# construction bid document addendum 01

project: Southern Maine Community College - Horticulture Greenhouse  
Midcoast Campus, Brunswick, Maine BGS # 3674

date: 12 November 2024

A20

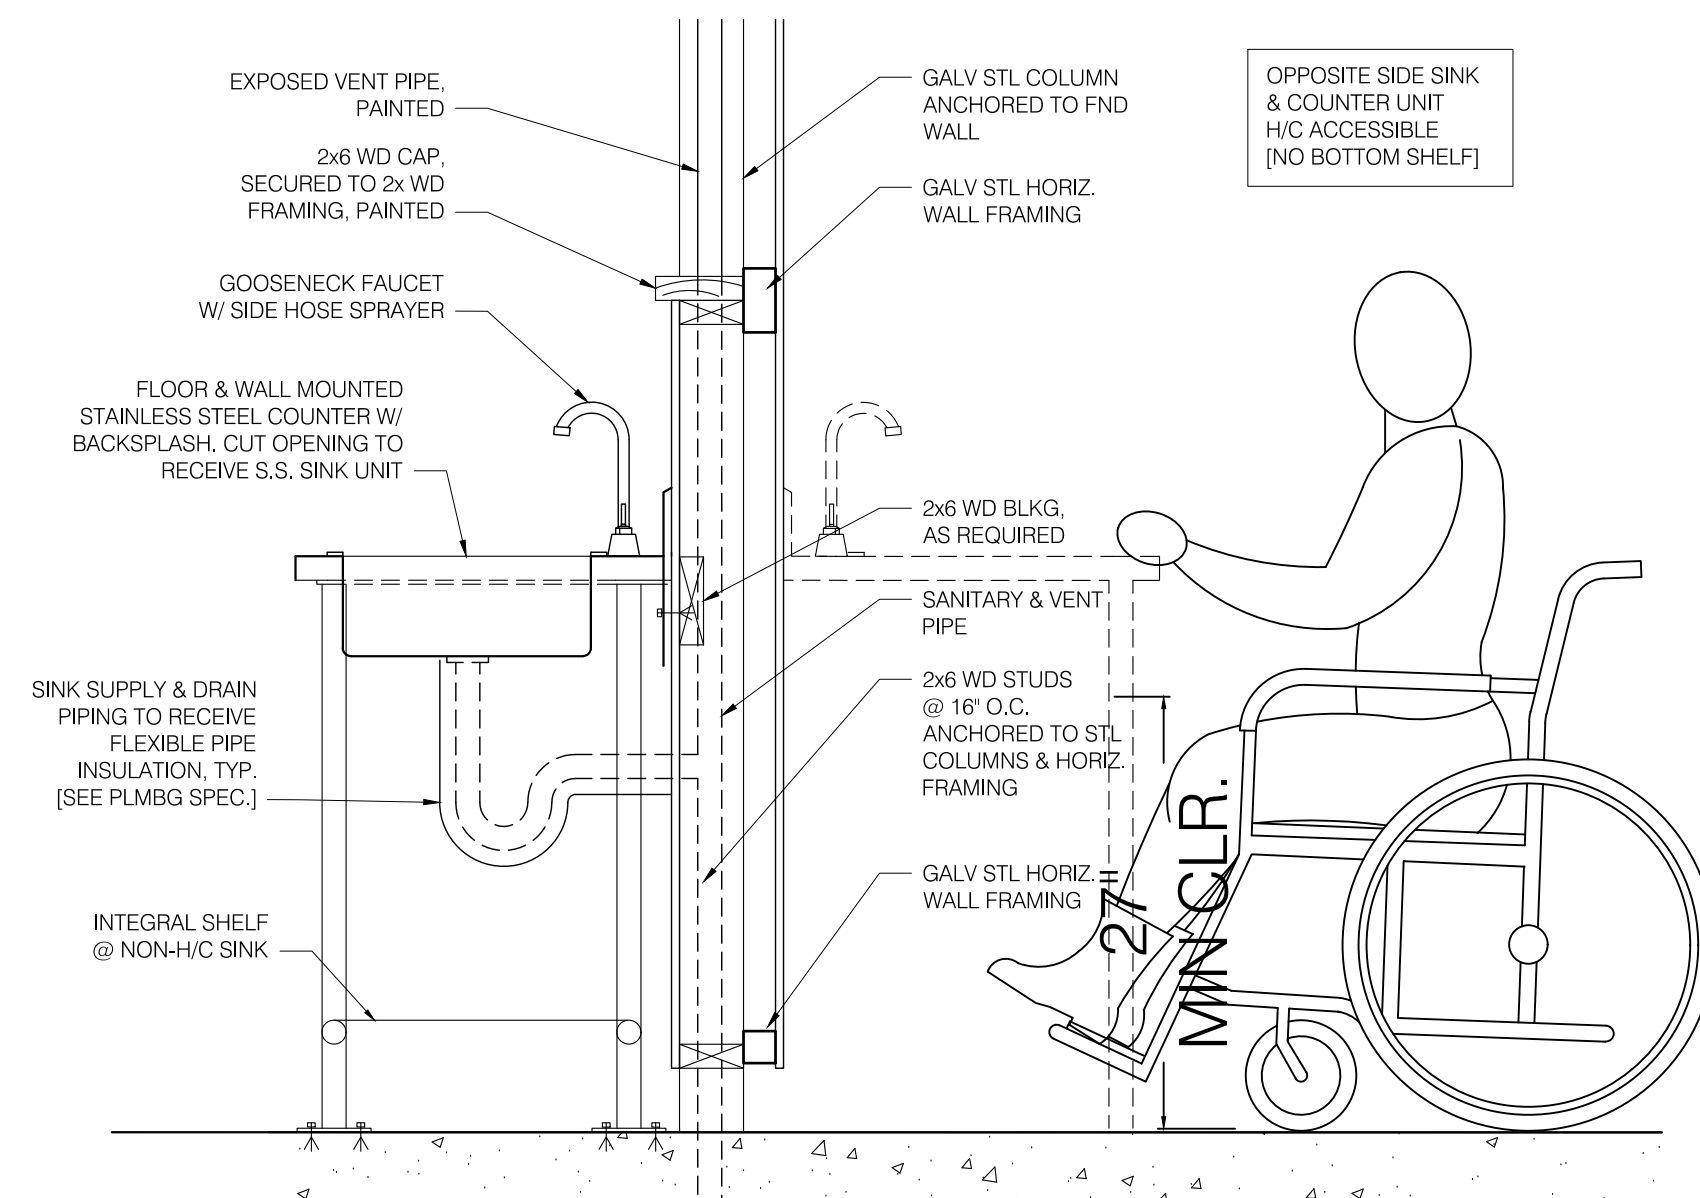
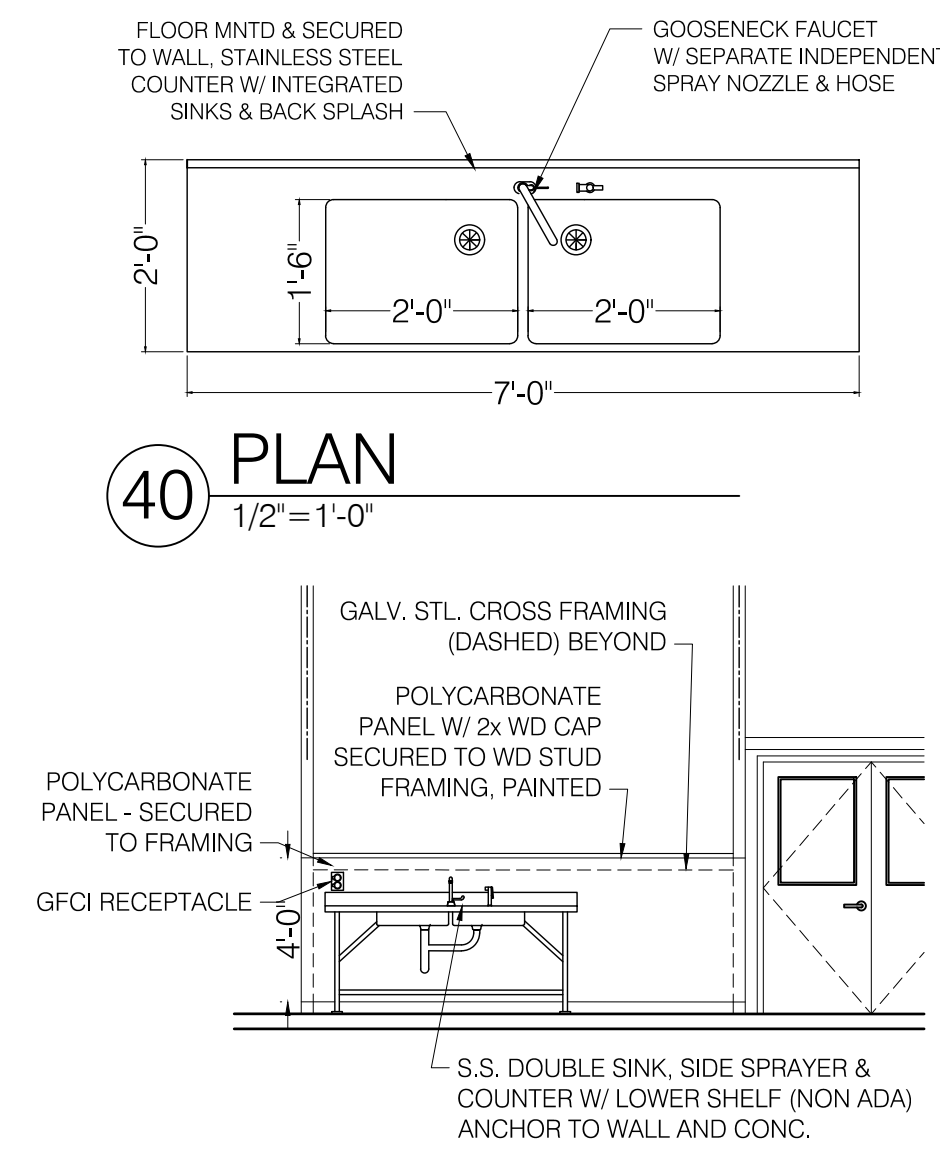
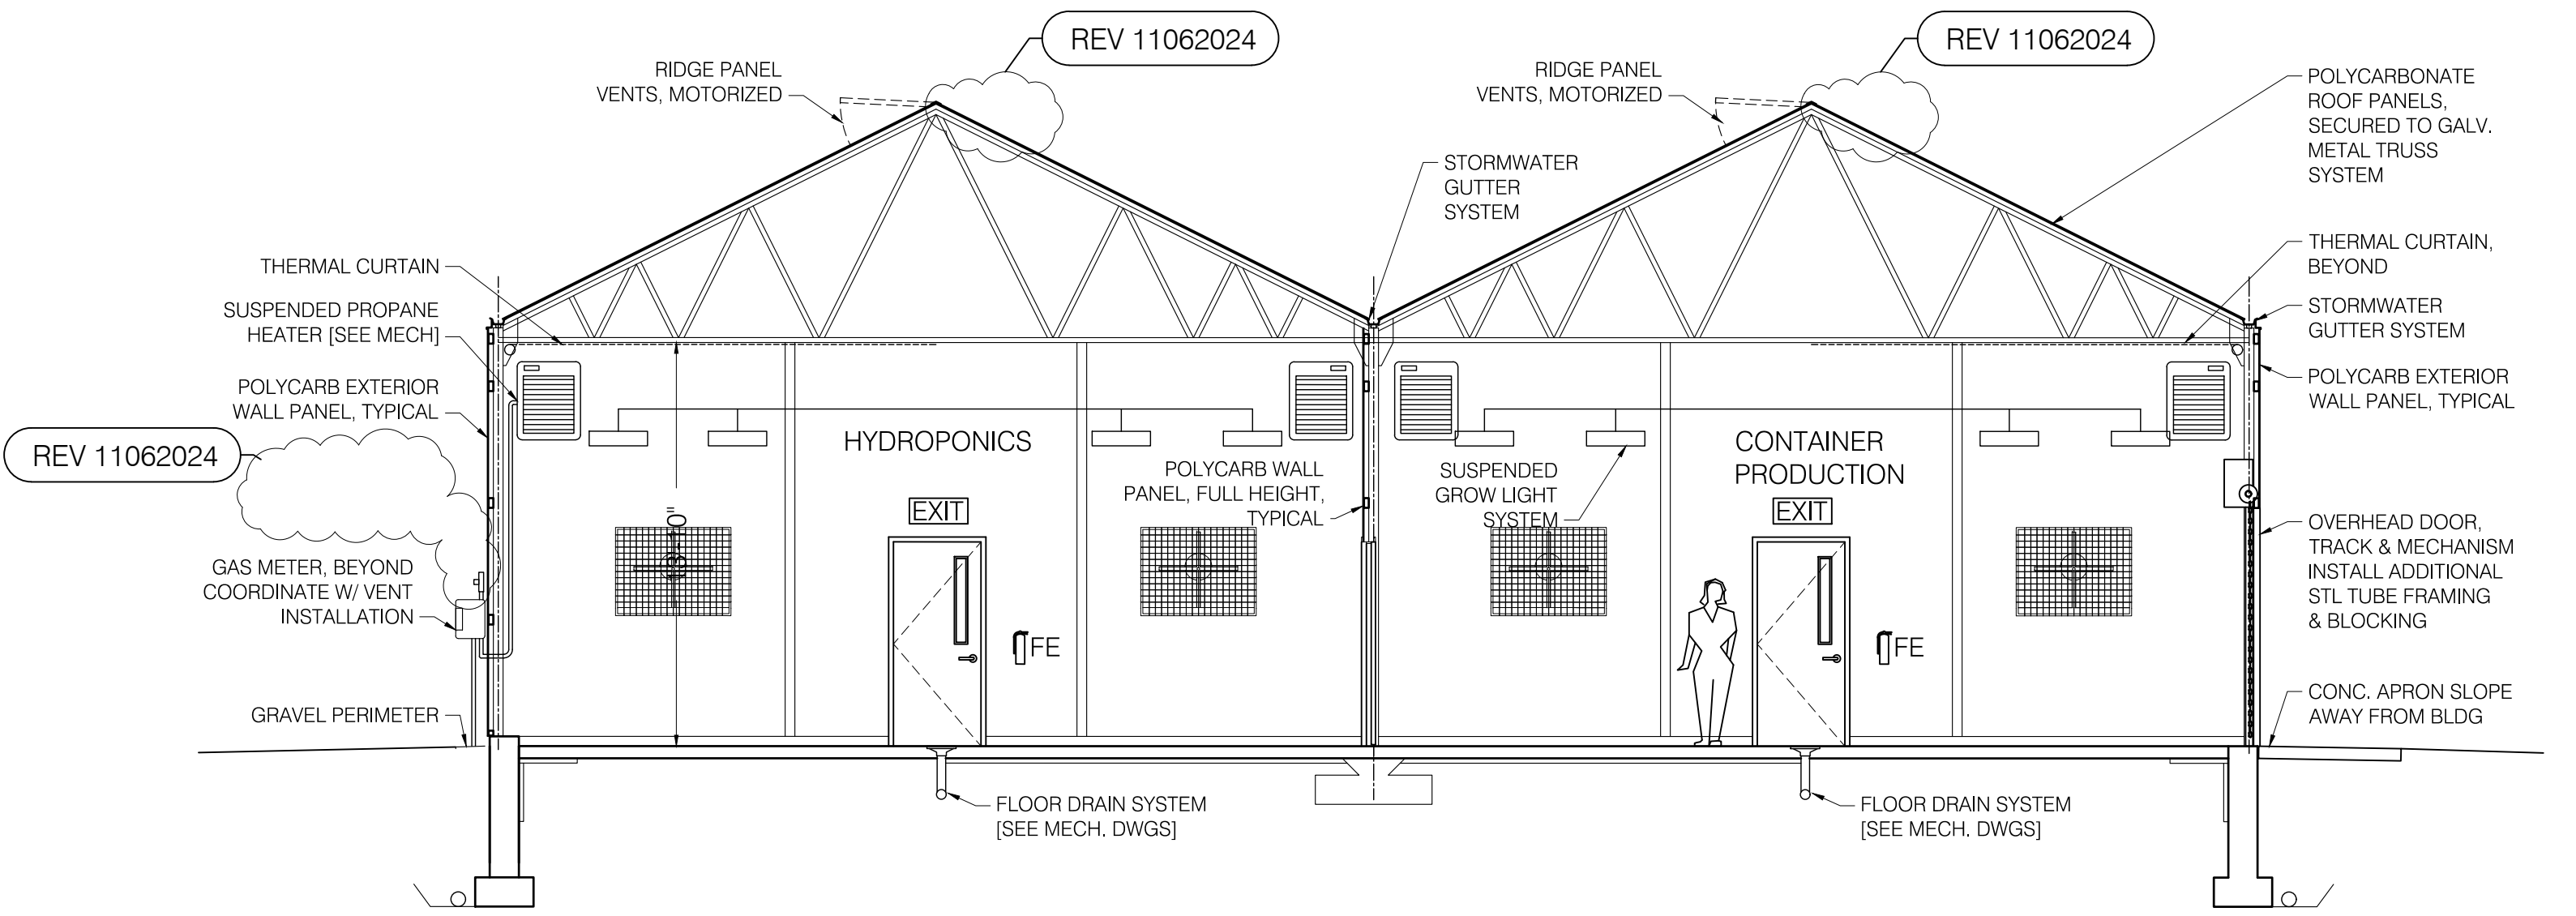
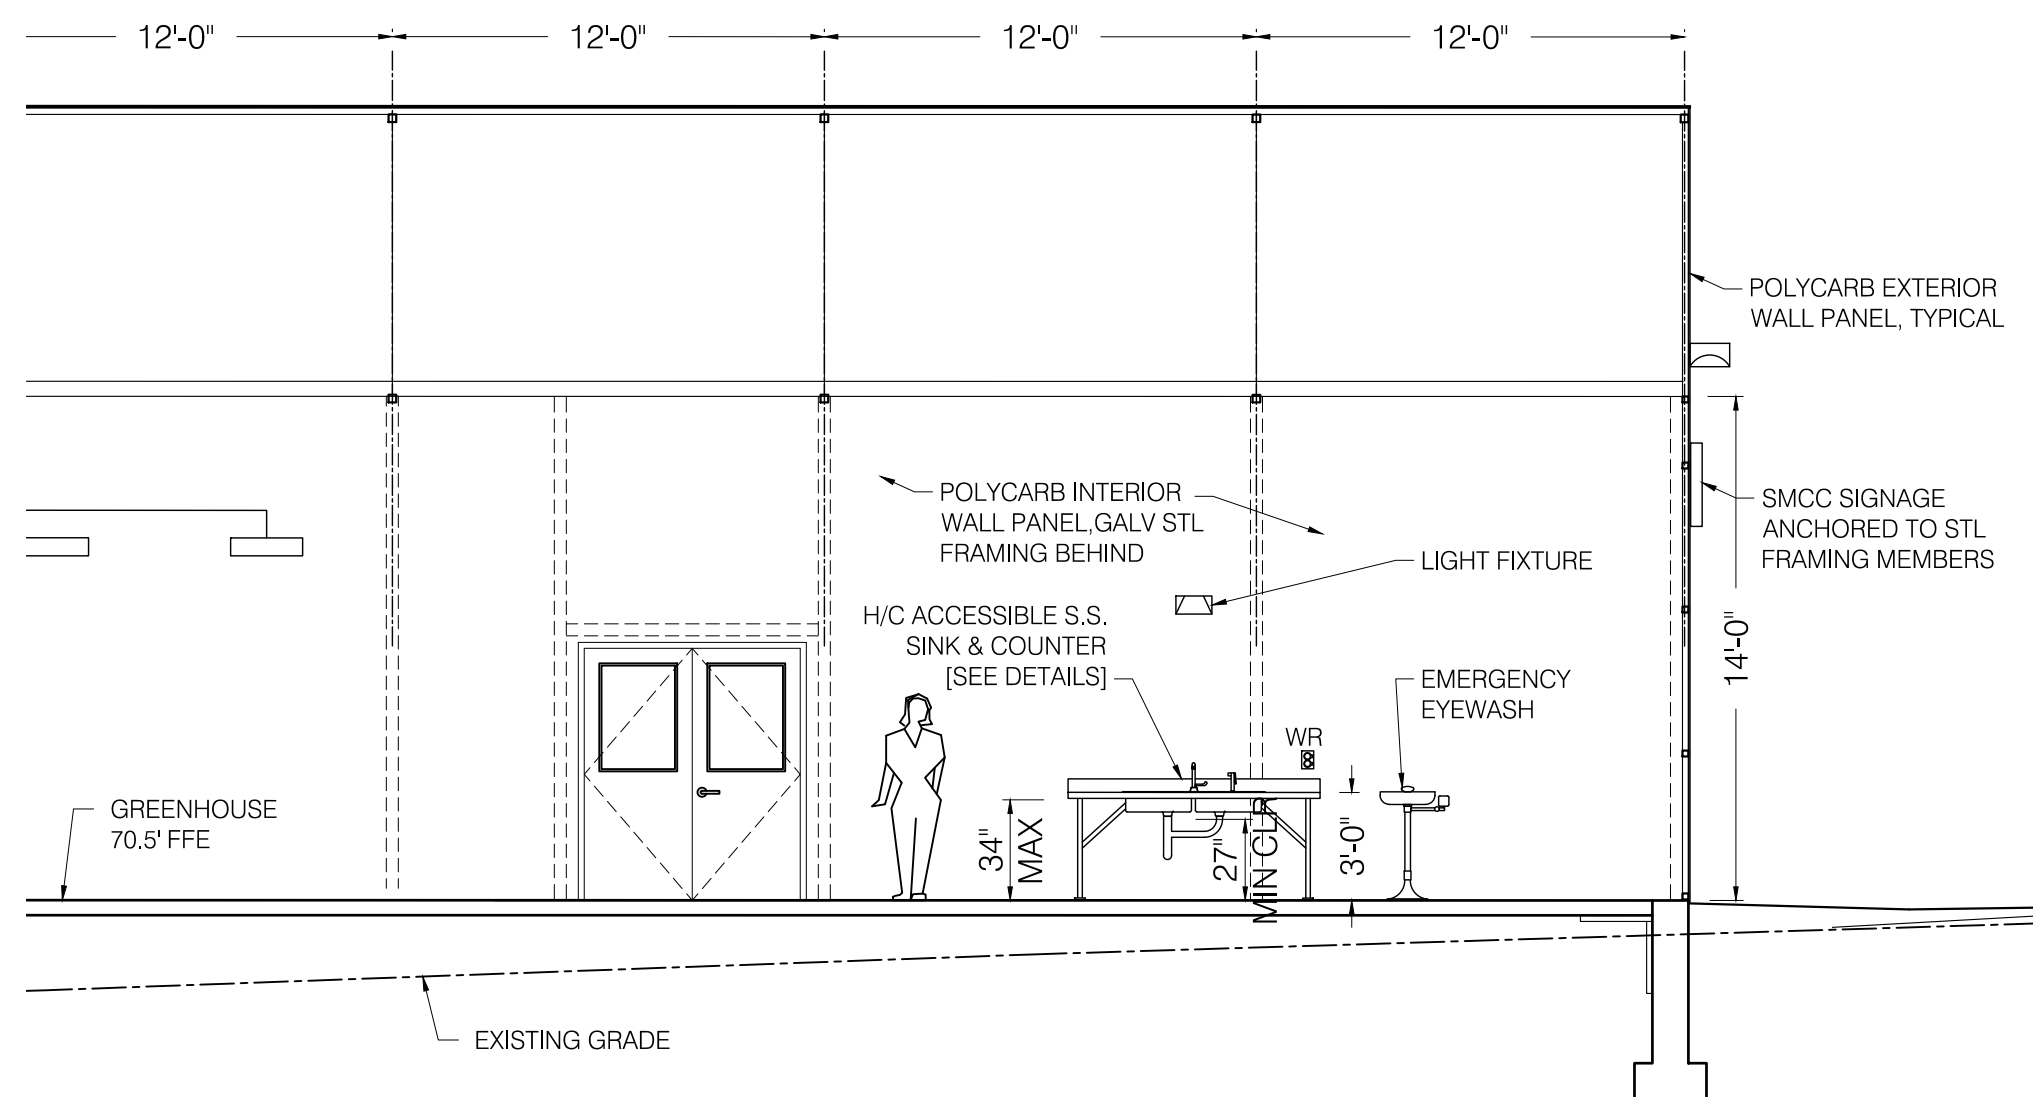
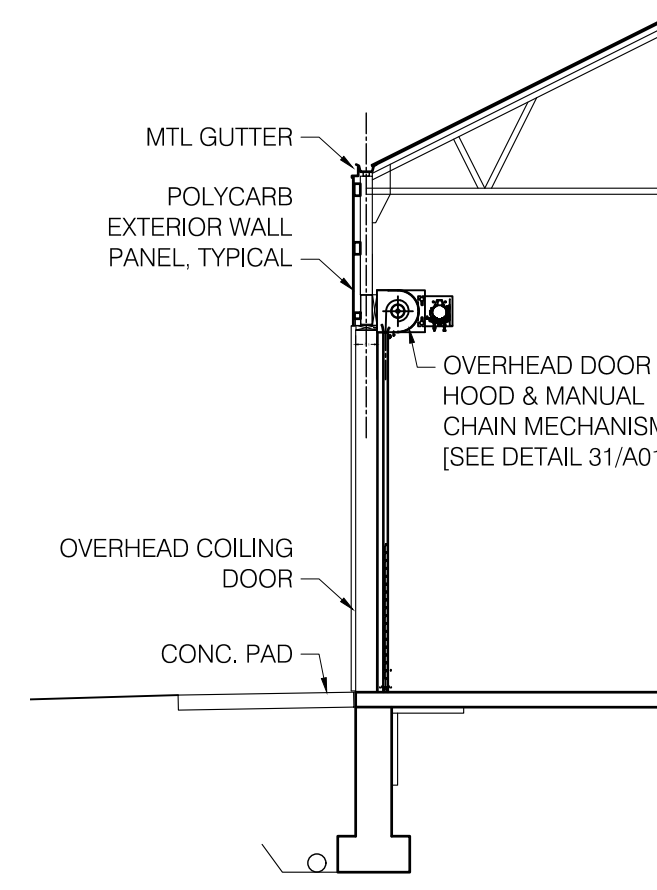
A20 EXTERIOR ELEVATIONS: Wall ventilation removed, ridge ventilation revised and exhaust fans and dampers revised.
